Title		
NanoFesc S1.0		
Size	Number	Revision
A4		
Date:	9/19/2021	Sheet of
File:	C:\Users\...\Excavator_S01_P01.SchDoc	Drawn By:

PUSHBUTTON BOARD

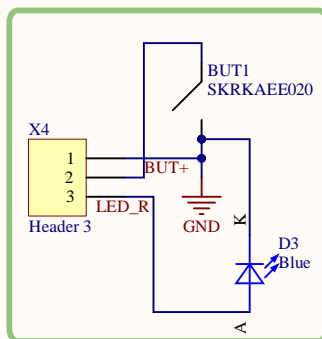
Change Button footprint (bigger and double)

MOTOR CONNECTORS

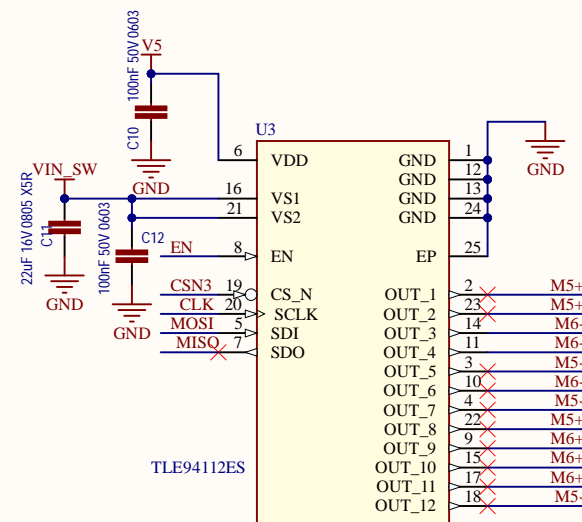
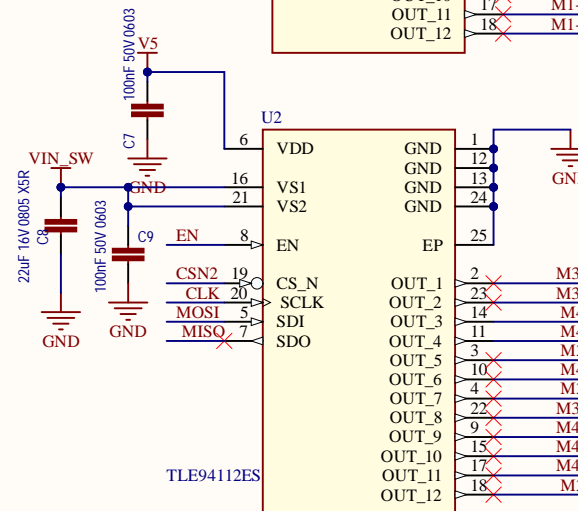
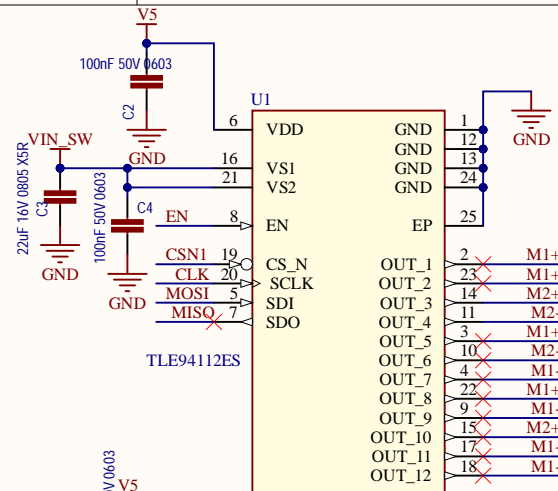
ADD jumpers

to set current on 2 motors from 2A to 4A. But set defaults all motor 3A.
